7.1.2 TPA/56692 - 26-28 MARSHALL AVENUE CLAYTON - DEVELOPMENT OF 5 STOREY STUDENT ACCOMMODATION BUILDING

EXECUTIVE SUMMARY

This application proposes the development of a five (5) storey student accommodation building for 73 students. The application also seeks a reduction in the prescribed car parking requirement.

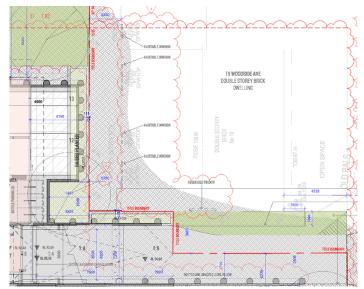
It is important for Council to consider whether the development minimises the impact to neighbouring properties, through suitable setbacks from adjacent secluded private open space to enable the provision of screening trees.

The site's irregular shape sees the building wrap around the dwelling and north facing secluded open space at 19 Woodside Avenue.

The setbacks of the basement and location of the vehicular accessway significantly affect the ability to plant screening trees to minimise the impact of the building in this location. The basement is setback 700mm between piers from the rear boundary of number 19, relying on a raised planter next to the building to accommodate trees.

This inadequate treatment also occurs on the side boundary of number 19 Woodside Avenue where the accessway and basement entry are positioned. Whilst a landscape buffer is provided, it is only 600mm wide and is insufficient to provide meaningful landscaping.

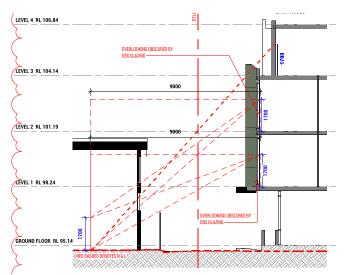
The proposed building will not cast any additional shadow into the north facing secluded open space of 19 Woodside Avenue or to the rear unit of 27 Beddoe Avenue. There will be some new overshadowing of 25 Beddoe Avenue, however based on the plans of the student accommodation building currently under construction, there will be no shadow cast on the main area of communal outdoor open space between the hours of 9am and 3pm at the September Equinox.

There is no overshadowing to an objector's property at 24 Marshall Avenue, located to the north of the subject site.

It is also noted the proposal does not overshadow any existing rooftop solar energy systems on dwellings on adjoining lots.

Overlooking Section Diagram to 19 Woodside Avenue

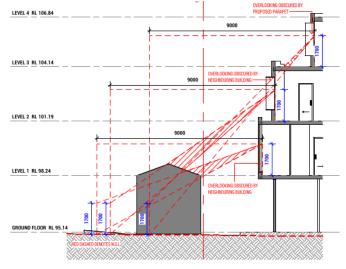
Level 3 is provided with obscure glazing to two east facing windows to prevent overlooking into the secluded open space of 19 Woodside Avenue. No additional screening would be required in that elevation as overlooking within nine metres will be obscured by the building's parapet. The

south facing windows also not require treatment for this open space area due to their setback, and encroaching parapet and fencing.

Overlooking diagram

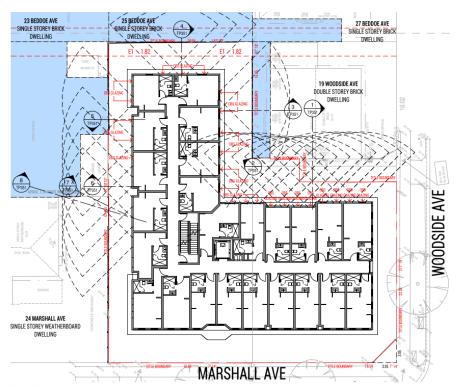
At levels 1 and 2 windows have obscure glazing where they would allow overlooking into adjoining secluded areas. The finished floor level of the ground floor is well below 800mm at the neighbouring boundary lines, so windows do not require screening.

It is considered the proposal would be unlikely to impact neighbouring properties through overlooking.
